General Service Bulletin

TAM7 Pump Down Issue

Models: TAM7 Air Handlers (See page 5)

ORDER No: **SSA-SVB26A-EN**

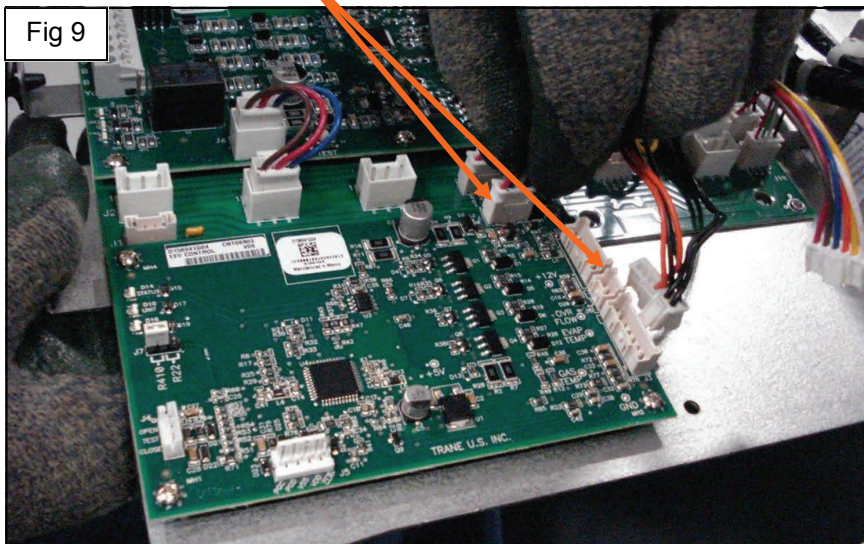
8. Inspect EEV control board. If the board is CNT06879, it should be replaced with CNT06903 (See Fig 8). If the control board is CNT06903, skip to step 14.

If you have a TAM7 matched with an unloading scroll compressor outdoor unit that experiences periodic pump down conditions, replace the EEV control board CNT06879 with CNT06903. If CNT06903 is already installed, follow normal troubleshooting procedures to determine the root cause of the problem.
